Flex PLI Drawing Review

Juan Luis Pascual Abad
Project Engineer

Issue 1 – 13/12/2013

133-5521

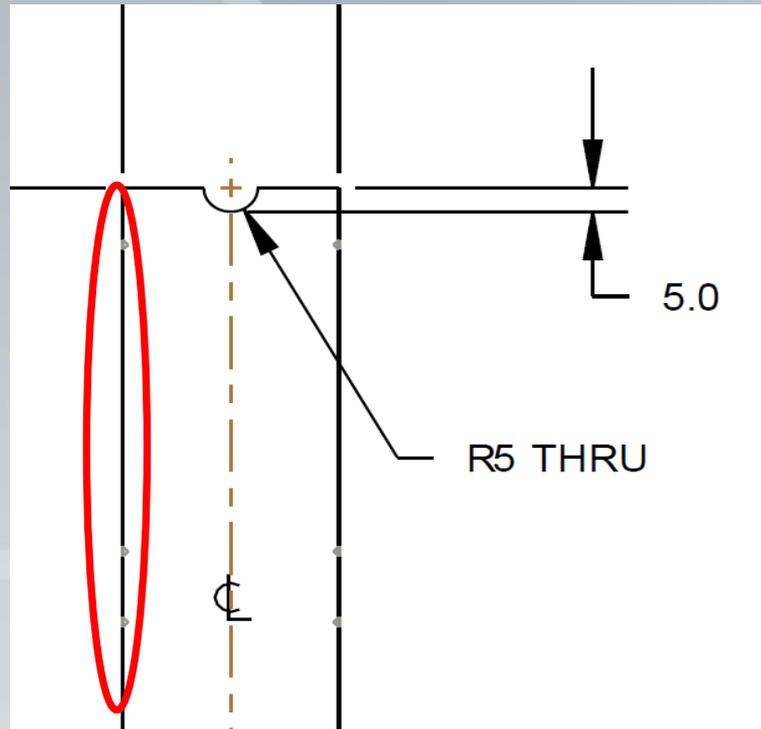
- In one drawing (washer 133-5521) the material differs between drawing (S.S.) and SN03 (aluminium)

Aluminium or S.S.?

**Material specification has not been
modified**

133-5507, 133-5307 for example

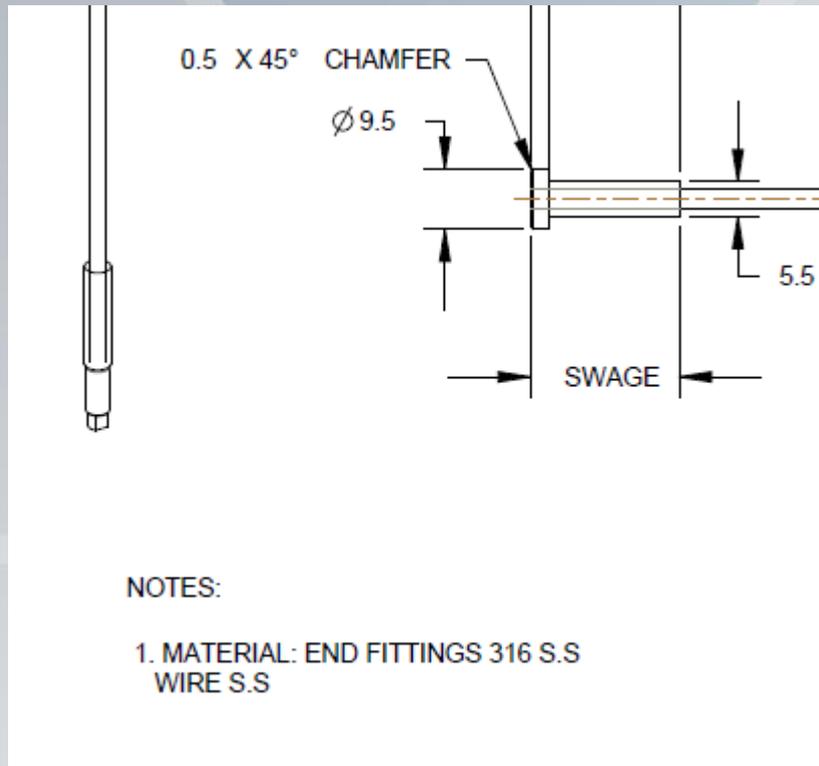
**Features visible in
view with no
dimensions
referencing them**

Is more information required to define material?
